SERVICE LETTER 235

Retention of Fire Boss Hopper Fill Valves

Aircraft Makes/Model(s):	Float Model(s):	Compliance: Optional	By: MAB
Air Tractor AT-802 & AT-802A	10000A	Part Number: 1011930	Approved: SDW
		Date: 7/13/2021	Revision: A

Figure 1

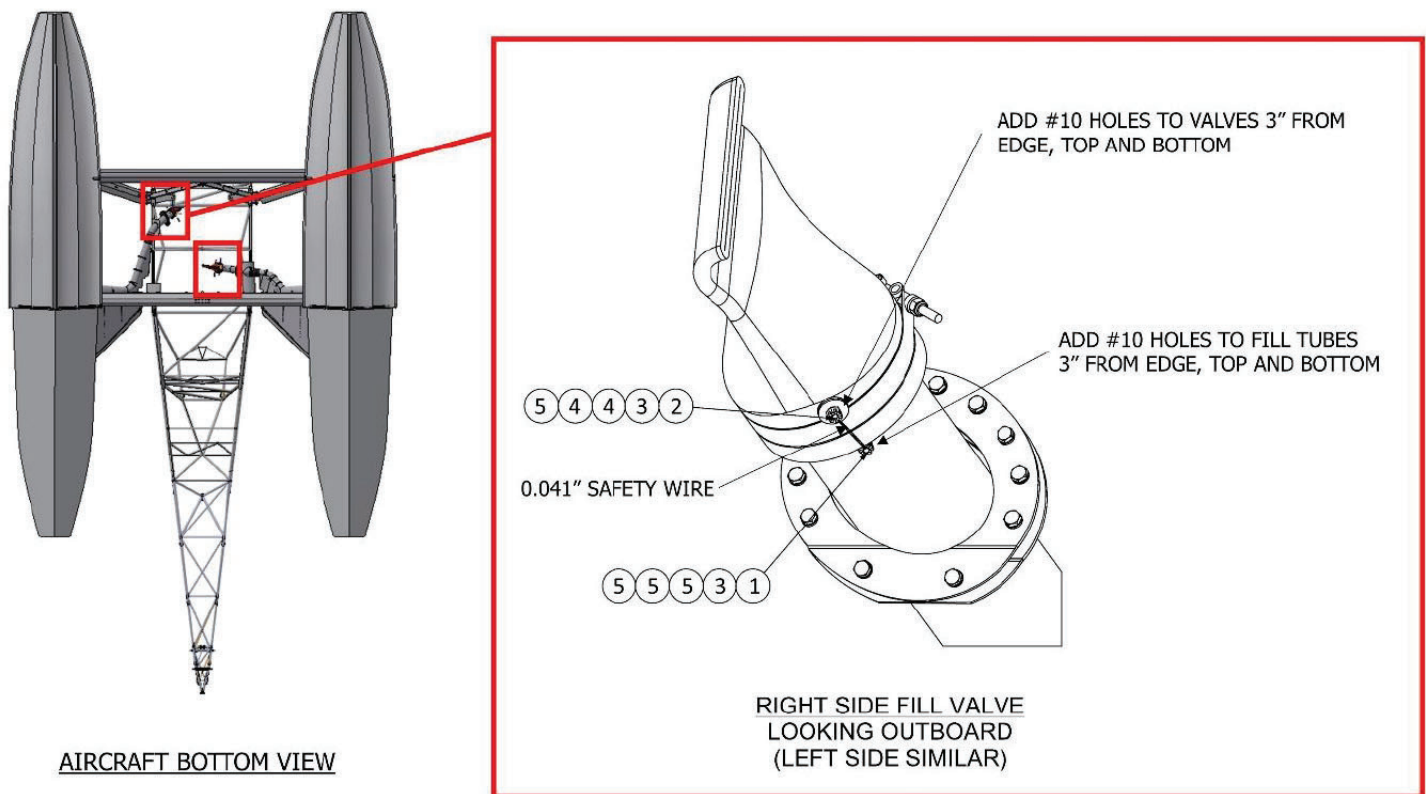
Due to the high flow rate in the fill system, it is possible for the fill valves to become dislodged from the fill tubes. This service letter provides instructions for adding studs and safety wire to the valves and tubes.

1. Gain access to the two fill valves located within the hopper. See figure 1. If opening the fire gate, disarm the system while performing maintenance.
2. Loosen clamps and remove both valves.
3. Add (2) #10 holes to each valve and to each fill tube, one on top and one on bottom as they sit in the aircraft. The result is (8) total holes for the whole aircraft. Place these holes 3" from the edge of the valve/tube.
4. Create studs at these locations using the hardware identified in Figure 1 and Table 1. Seal with Pro-Seal as needed.
5. Reinstall valves and tighten clamps.
6. Attach 0.041" safety wire between the newly created studs in accordance with AC 43.13 (4 total locations). See Figure 1.
7. Reinstall aircraft panels and close fire gate as needed.
